TECHNICAL NOTE Addendum to Best Available Techniques and Operating Techniques (SLR, 2022)

Mineral Processing Facility – Updated to BAT Compliance for Area 115 – Primary and Secondary Crushing (21st September 2023)

This technical note addresses the points raised in communications between the EA and DRL on the 11th of September 2023 in relation to Best Available Technique (BAT) compliance of Area 115 (Primary and Secondary Crushing). It is assumed that the reader will have knowledge of the submissions and responses to date, and thus this document will look to directly address queries raised by the EA on the date above. For an overview of the process including detail of Area 115, please refer to TW-NTS-8012-517-001 Non-Technical Summary.

Figure 1.4: Updated Primary Crusher Arrangement

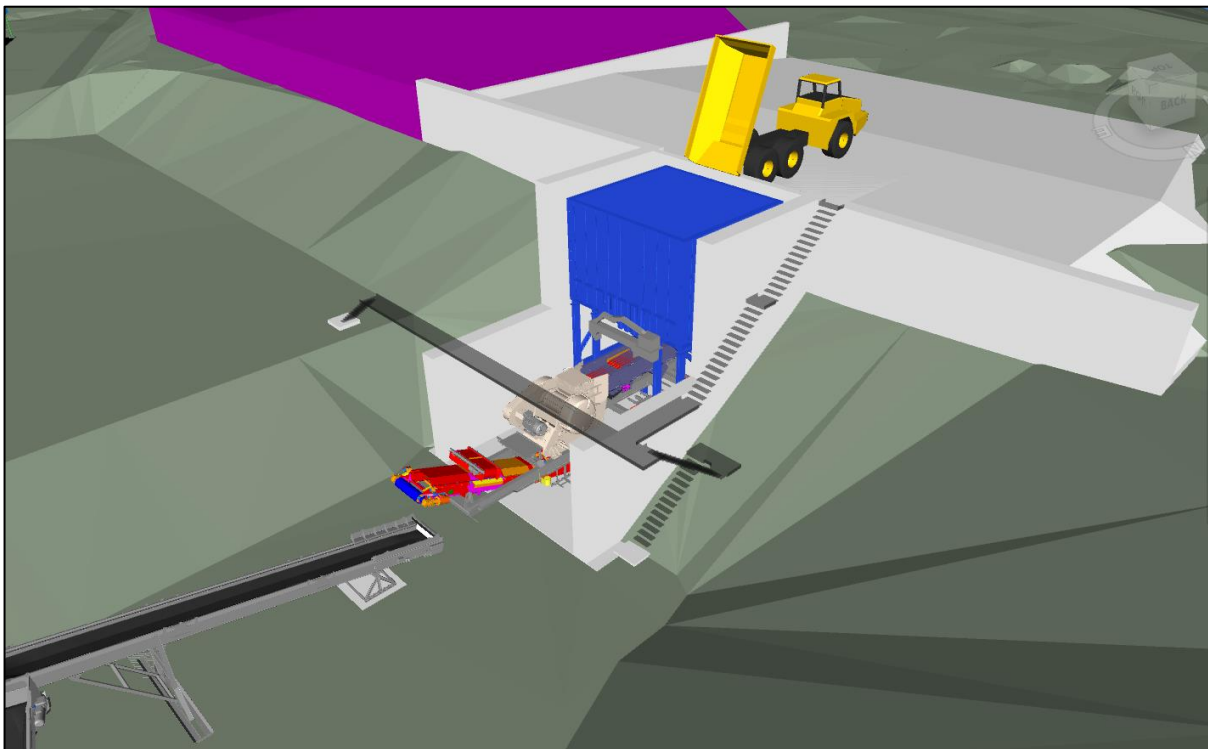
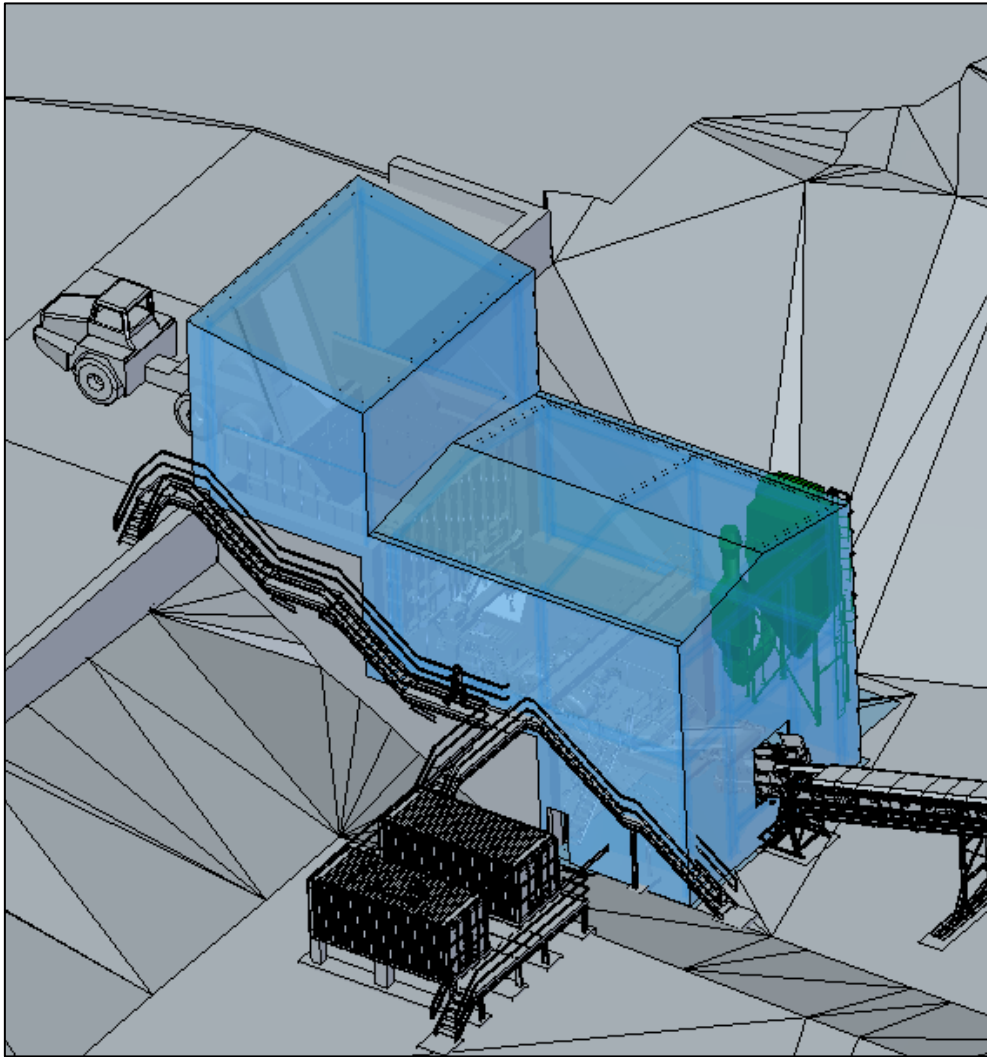
In communications between DRL and the EA (11th September 2023), the position of the EA is that the previously proposed primary and secondary crushing arrangement and mitigations therein are not BAT compliant. This relates to the use of PGN 3/16(12) for mobile crushing and screening rather than PGN 3/08(12) for Quarry Processes.

The fundamental difference between the two guidance notes in relation to Hemerdon is the requirement, in PGN 3/08(12), for containment to meet emissions limits and provisions. As outlined in Table 5.1 of the guidance note, crushing, grinding, screening and separation activities must have containment within housing, dust abatement in the form of bag / cartridge filters, and dust suppression.

DRL have designed containment for both the primary and secondary crusher within Area 115. As shown in figure 1.4, the building will be open at the front end allowing for direct tipping from the Run of Mine (ROM) pad into the ROM Feed Bin. At the discharge end of the primary crusher, an opening allows room for the conveyor head taking material to the secondary crusher. As per the mitigations outlined within the BS 4142: 2014+A1:2019 assessment (SLR, 2022), conveyor openings will be inherently reduced as per paragraph 5.1 within PGN 3/08(12). In addition to these openings, the primary crusher building will be fitted with a single roller shutter door and two pedestrian doors. A Standard Operating Procedure (SOP) for the use of the roller shutter doors and mitigating noise leakage has been provided in the Noise Management Plan (WSP, 2023) (Appendix C). As per paragraph 5.5 of PGN 3/08(12), pedestrian doors will be self-closing and thus closed when not in use.

In addition to the containment, each building will be fitted with a dust abatement system as indicated by the green structures in figures 1.4 and 1.5 and grey structures in figure 1.6. This system will contain a bag filter system that will generate a negative air pressure allowing dust to be pulled through the abatement plant. The bag filtration system will be designed to achieve emission levels of less than 50mg/m³. DRL propose to install a continuous indicative monitoring system that will possess the following:
